Russo Park RFP

Questions/RFIs:

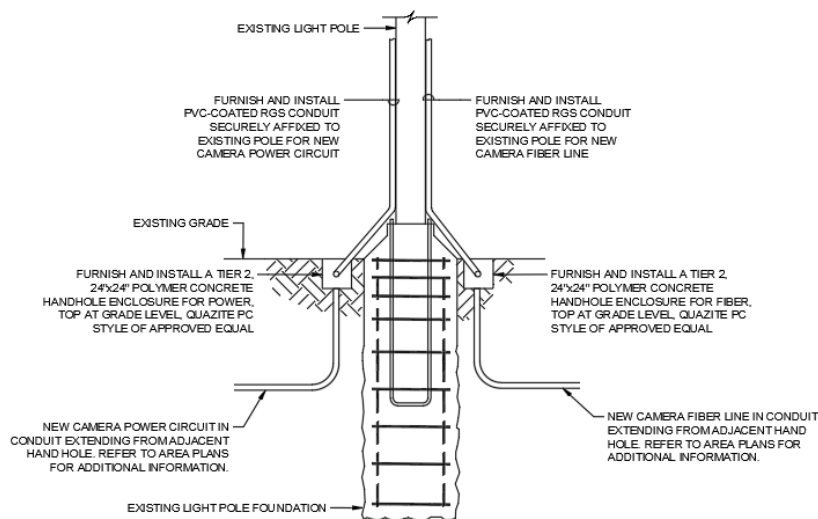
20. Drawings E-101, E-102, E-103, and E-104 – ALT #1 vs. ALT #2: Please clarify the differences between ALT #1 noted on these drawings and the ALT #2 reference notes. The drawings reference both alternates, and it is unclear which scope applies to the base bid and which applies to the alternate. Is it that conduits are Base Bid and the actual Camera power, fiber and all install is the add Alternate?

Response: Refer to answer to question #18.
